Feedback of 2025 IDRC Review Report

中國科學院高能物理研究所
Institute of High Energy Physics
Chinese Academy of Sciences

ELECTROMAGNETIC CALORIMETER

Figure 7.21: Energy deposition of 6 GeV and 60 GeV photon with and without the energy correction. The directions of the photons are $\theta \in [40^\circ, 140^\circ]$ and $\varphi \in [0^\circ, 360^\circ]$.

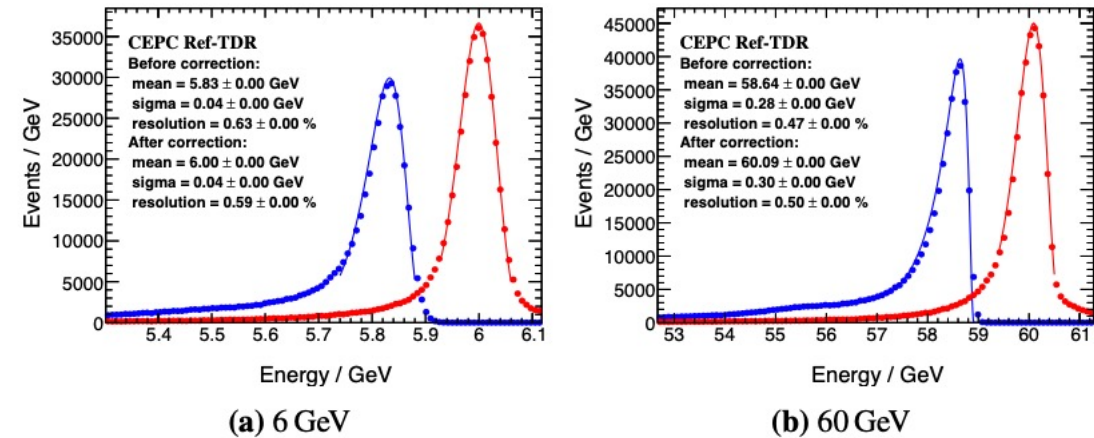
- Advance preliminary engineering of the gaps between modules and fully assess their impact on reconstruction performance.
- Current status
 - Engineering designs, including readout boards, cooling sheets and active cooling pipes, are added
 - An energy-correction algorithm has been developed to correct cluster energy loss in module cracks
 - Plots of EM performance have been updated, where incident photons are uniformly distributed around ECAL modules including crack regions
 - Updates in Section 7.2.5 and 7.3.4

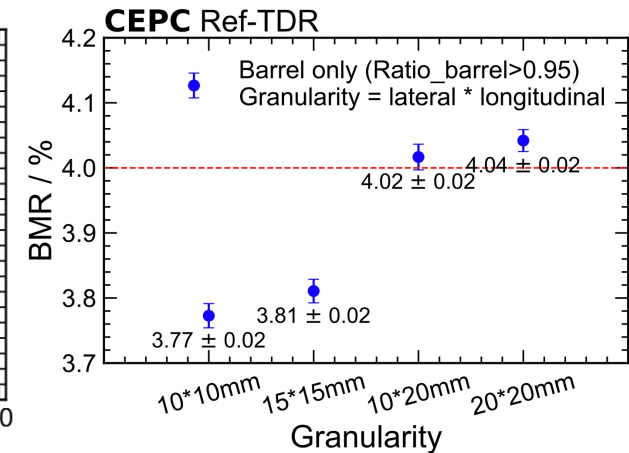
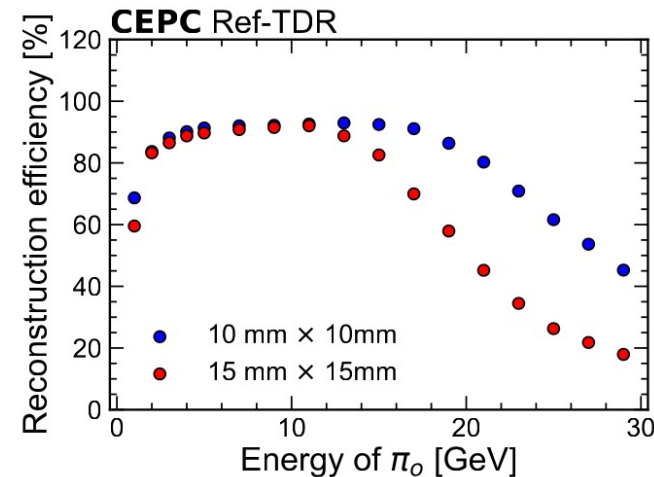
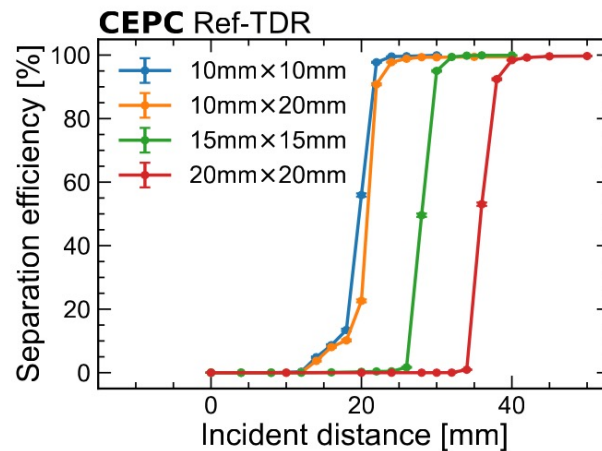
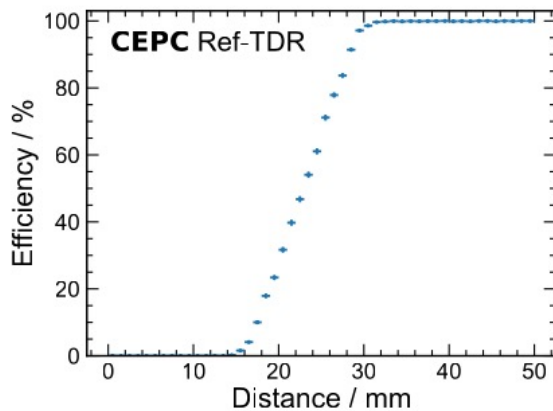
- There is no mention of separation of showers or individual particle depositions. The parameters mentioned are energy resolutions without mentioning the segmentation (granularity) needed to achieve particle flow performance. We suggest adding mention of needed segmentation or granularity.

- The two-particle separation performance (separation efficiency) is updated in Section 7.2.2 and 7.3.2
- The required granularity of 15x15 mm is added in the updated version.

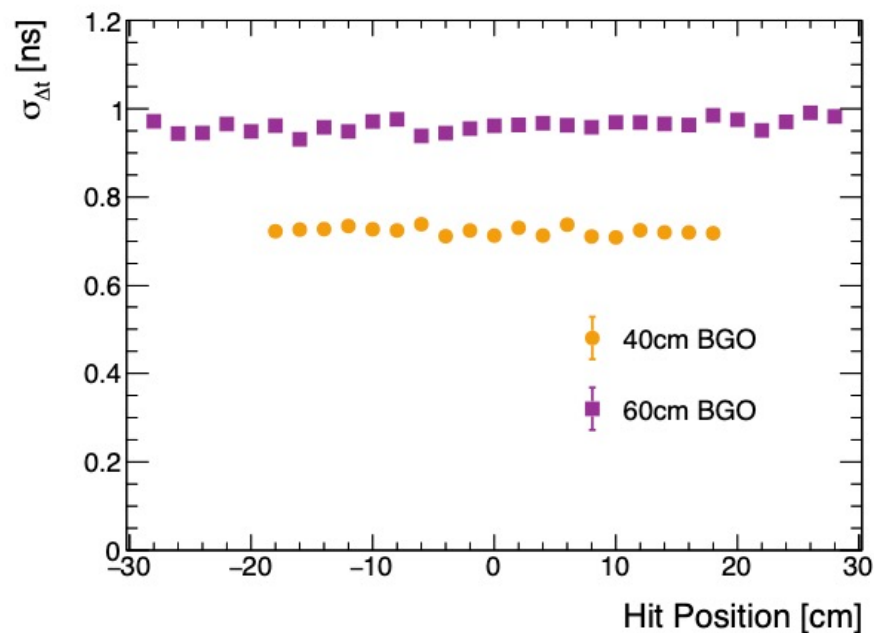
- The discussion about timing performance (Section 7.4.3) remains confusing. The time resolution is defined as “the standard deviation of the time difference of the time stamps of SiPM signals from the two ends of a crystal”. This quantity is not independent of the hit position and does not correctly quantify the precision with which the position of a deposition can be reconstructed. A deposition in the centre of the bar, would give a $\Delta t = 0$ with an RMS from the resolution of the device. A deposition near the ends of the bar would give a distribution with the same RMS centered at $\Delta t = \pm L/2v$, where L is the bar length and v the velocity of the light in the crystal. For a uniform hit distribution, the RMS will therefore get a contribution from the propagation path of $L/(v \sqrt{12}) \sim 0.6$ ns for $L=40$ cm, $v = 1.5c$. This should be added in quadrature to the genuine time resolution from the detector and readout. In Fig. 7.31 at $L=40$ cm, the resolution is 0.7 ns, which is consistent with 0.6 ns from propagation (+) 0.4 ns intrinsic to the detector, which you can read from the measurement with $L=2$ cm crystals. At $L=60$ cm, your measured resolution is almost 1 ns, which is again consistent with an $L/(v \sqrt{12}) \sim 0.9$ ns (+) 0.4 ns. So, while your data show the expected behaviour, your interpretation of the results is different. At L 6602, you conclude that at $L=40$ cm, the resolution is 700 ps (500 ps per end), while your data indicate a resolution is 400 ps/MIP (280 ps per end), which would scale to a resolution of 100 ps already at 200 MeV (per crystal). A better measure of the time resolution is provided by the RMS of the sum of the two timestamps, because the sum of the two propagation times is independent of the hit position. A plot of this quantity should clarify what is the actual resolution. You may still have some dependence on the bar length, because the light output is lower for longer bars.

- We have thoroughly reanalyzed the testbeam data using the definition in TDR and the suggested definition in the IDRC review. Plots are not put in the TDR but will be provided separated (next page).
- Conclusions: the 1-MIP timing resolution along crystal length is quite uniform; the 1-MIP timing resolutions from two definitions are mostly the same.
